Flat No	6-103.	QC report stage	stage - 18	SL No.	42122.
Company	MEMULP	Project	GMR	Phase	-
Prepared by	srini.vas.	Sign	srini	Date	09/10/23
Project Manager	K. Narasimha	Sign	(Signature)	Date	09/10/23
Receipt by QC date		Sign		Other	
Receipt at HO date		Sign		Other	
Checked By MD on		MD Sign		For filling	☐ Yes ☐ No

Quality Control Check Report. Stage: After Finishing Stage III (Apartments)

Quality Control Check Report. Stage: After Plumbing & Electrical (Apartments)

Quality Control Check Report. Stage: After Brickwork (Apartments)

6-101
[Electrical]

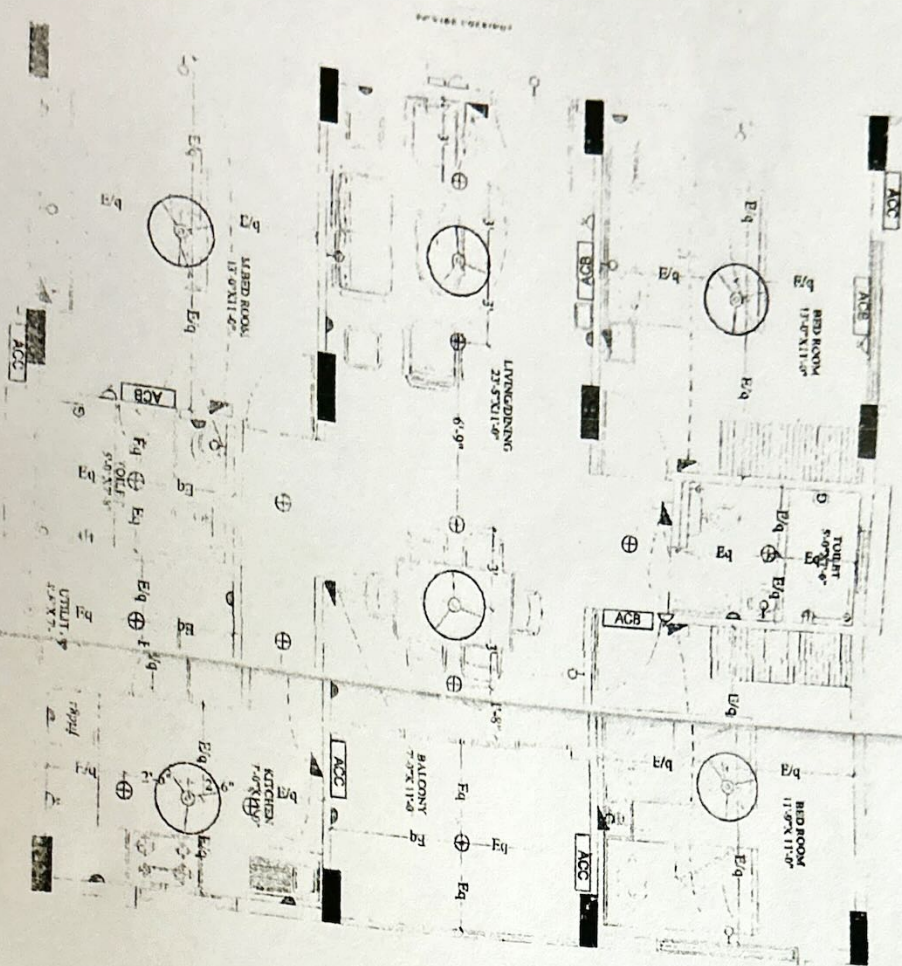
Miscellaneous check	☒ Yes ☐ No
Screeding done on walls upto 12" outside bathroom/utility	☒ Yes ☐ No
Bathroom utility filled with 4" water for water proof check	☒ Yes ☐ No
Hole packing done around all pipes in ceiling and internal walls	☒ Yes ☐ No
Remarks: NOTE :- ☒ Hole packing around pipes was not done properly.	
☒ In k.Bed, internal walls hole packing was not done.
